## ASSEMBLED COMPLETED CRAMSHAFT KIT

### PSA ENGINES 1.5 BLUE HDI (DV5R)

## TECHNICAL NOTE PSA ENGINES 1.5 BLUE HDI (DV5R)

### How to recognize the defective engine:

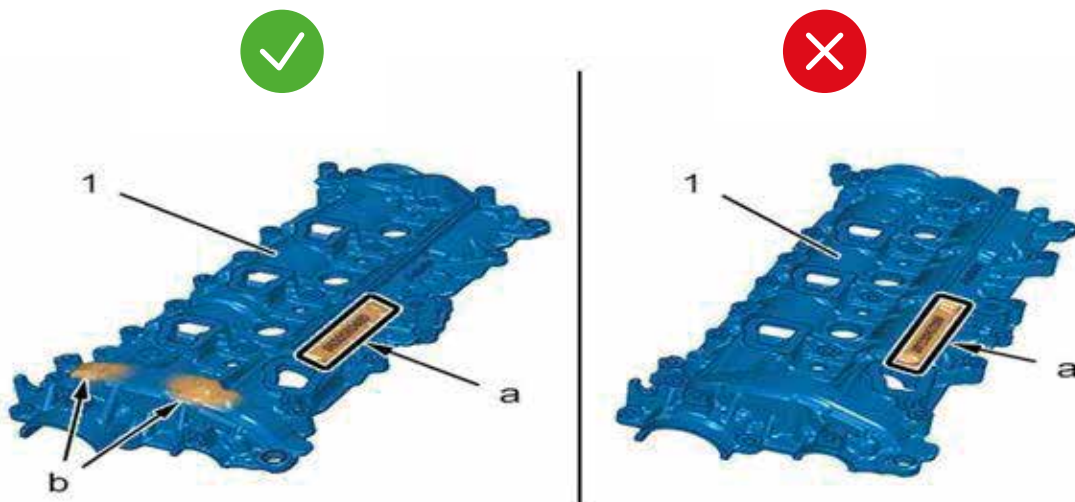
The 1.5 Blue HDI engine developed by PSA in 2018 has a problem: the oil-bath timing chain connecting the camshafts may wear prematurely, becoming noisy due to elongation and exceeding tolerance, and may eventually break or prevent the engine from starting.

Aware of the issue, PSA engineers carried out a major modification starting from January 2023 by adopting an 8 mm chain instead of 7 mm: new camshafts, a new timing chain kit, and a new cover. To distinguish the old version from the updated one, simply check the timing chain cover: the updated version has two small bumps with the new reference number: **98 305 804 80**.

Therefore, for non-modified engines, if the upgrade to the 8 mm chain version is not performed, it is recommended to use 5w30 oil instead of the originally specified 0w30, as it provides better protection for the chain gears when the engine is cold.
